# Special Bulletin

# SP13-328F

REVISION F THIS REVISION SUPERSEDES THE PREVIOUS VERSION.  
Alternator pulley flanged nut torque was 58 lbf-ft, changed for 75 lbf-ft.

## BOSCH HD10 ALTERNATOR REPLACEMENT Prevost vehicles

FIGURE 5

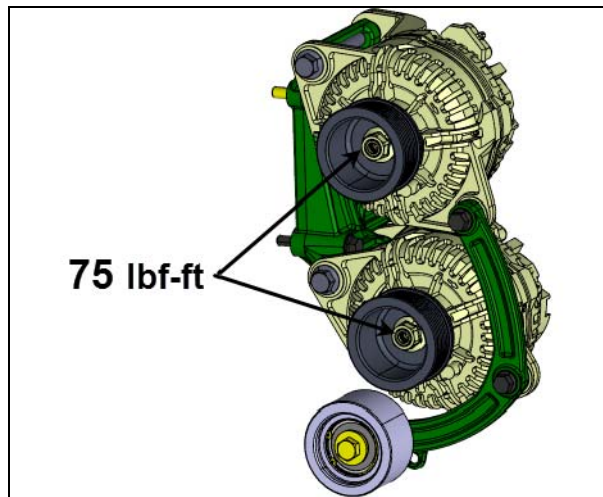
9. Mount pulley onto alternators (figure 5). Use Loctite 243 blue on threads. Tighten pulley mounting nut to **75 lbf-ft** using Prevost tool and a M10 12-points spline drive mounted on a torque wrench (refer to the end of this document for details concerning special tools).
